# ***City of Albuquerque***

RE: ENGINEER'S CERTIFICATION FOR CERTIFICATE OF OCCUPANCY  
APPROVAL, MECHENBIER LOT 5 (F22-D11A6), ENGINEER'S STAMP  
DATED 1-22-99

RE: DRAINAGE PLAN FOR MECHENBIER LOT 5 (F22-D11A6) ENGINEER'S STAMP  
DATED 4/24/98

# F-22/D11A-3 - APPROVED DRAINAGE REPORT

CITY OF ALBUQUERQUE, BERNALILLO COUNTY		NEW MEXICO	
LOT #5 TRAMWAY RIDGE			
MECHANICAL LOT #5 GRADING & DRAINAGE PLAN			
<b>McDowell Engineering Inc</b>			
Designed JSU	Drawn STAFF	Checked JSU	Sheet 1 of 1
Date APRIL 1998

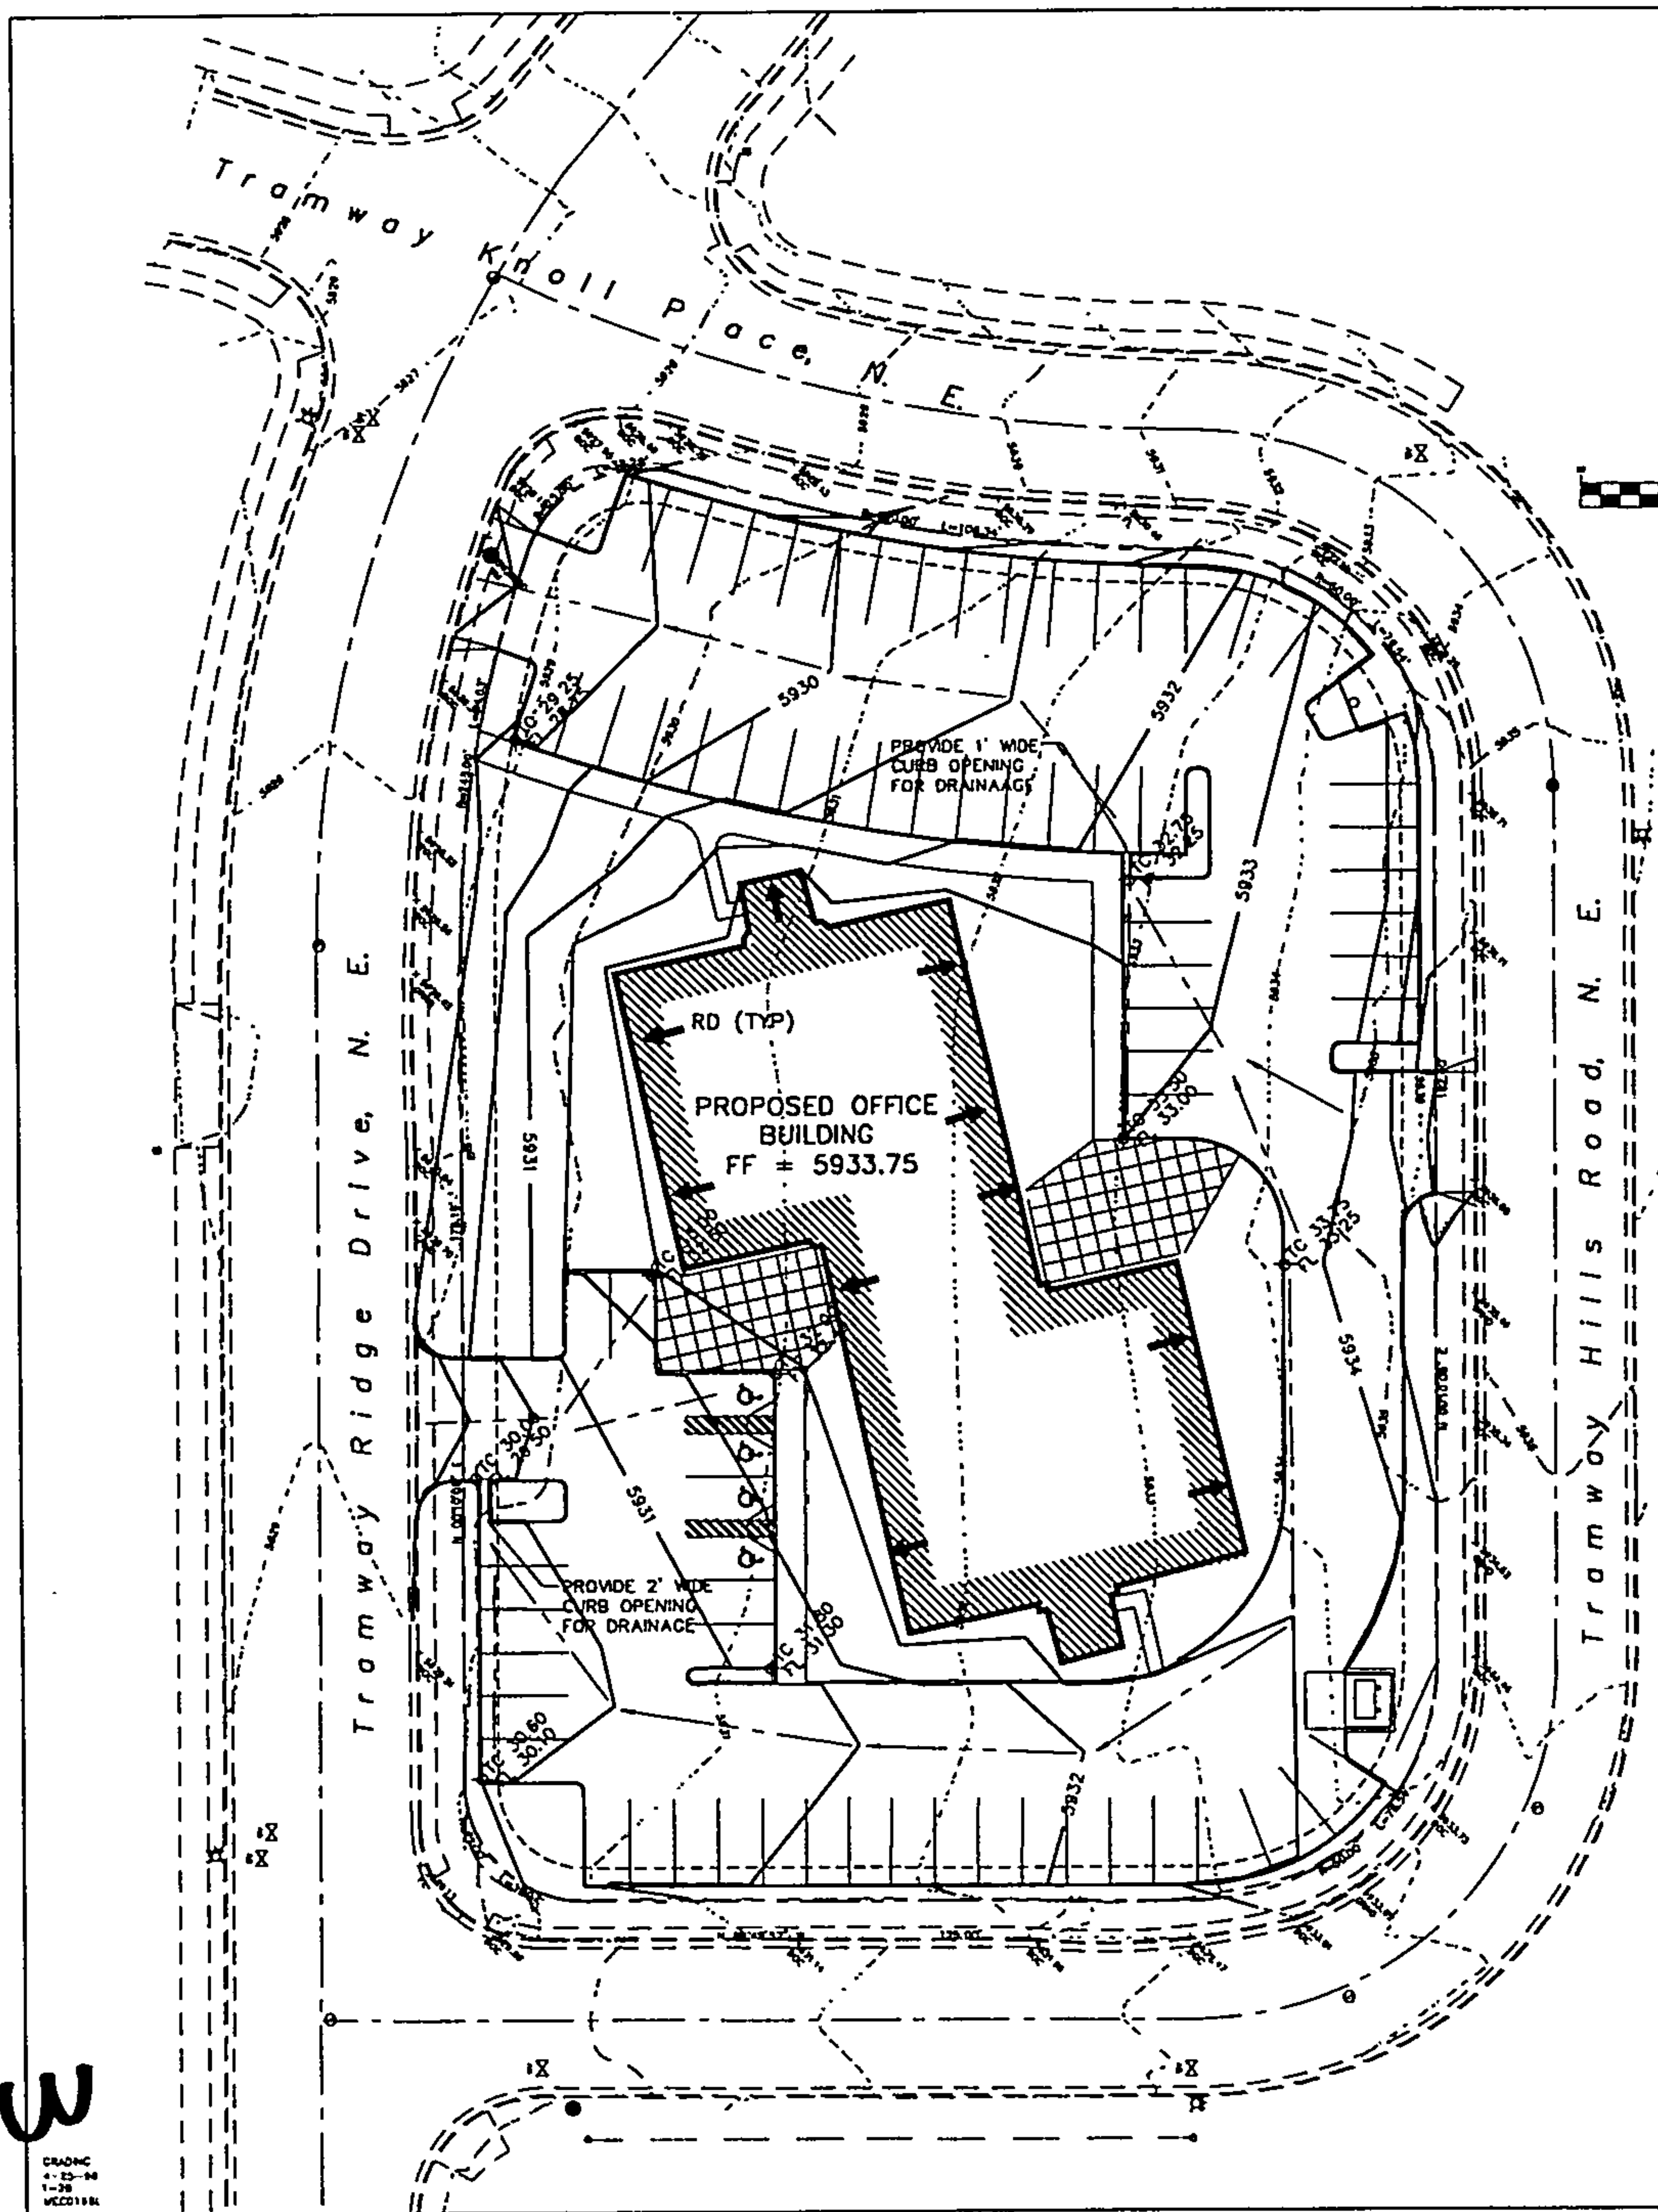
Please be advised that all the roof run-off must be routed to the asphalt from the landscape areas thru a curb notch or other means.

Please be advised that all the roof run-off must be routed to the asphalt from the landscape areas thru a curb notch or other means.

1. All the developed run-off from the roof area must be routed towards the asphalt. Your plan drawing does not indicate these.
2. Top of curb and flowline elevations must be shown on all the streets.
3. Without the flowline elevations, I can not determine if you have allowed for the one foot water block at the drivepads.
4. Please identify the slopes on the proposed asphalt swales.

1. We have modified the plan to route the roof area towards the asphalt.
2. The top of curb and flowline elevations have been added to the plat at the survey points shot. The curb is a COA standard curb, therefore, the flowline at the top of curb is 8" below the top of curb elevations shown on the plan.
3. We have added flowline elevations on the street near the driveways (see response #2 above). We have noted the water blocks provided at the driveways. The eastern driveway does not receive any offsite runoff, since it is located at the high point of the street, but a 0.6' water block has been provided. A 1' water block was not necessary and it would have made the entry even steeper than designed.
4. Slopes have been added to the plan at the asphalt swales.
